Access Compliance Report

Public Rights-of-Way

Intersection ID: 49895	Main Street: FERRELL_COMMONS_RD	Cross Street: PROSPERITY_COMMONS_DR	Location: SW
ADA ID: 881C4AF6519B	Ramp Type: PerpDiag	Initial Pass/Fail: Pass	Overall Compliance: No
Severity Score: 0			
Codes/Mitigation Info/Possible Solution		Field Measurements/Component Compliance

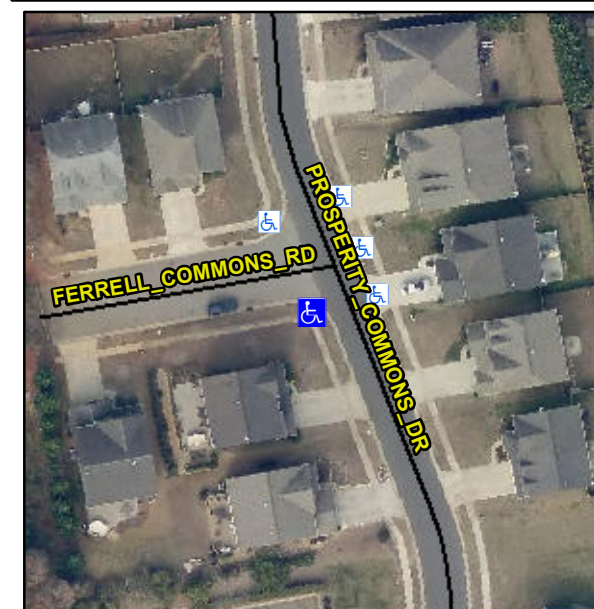
Not Found, R305.2, R302.7

Remove & Replace Curb Ramp With Two New Directional Ramps or Equivalent.
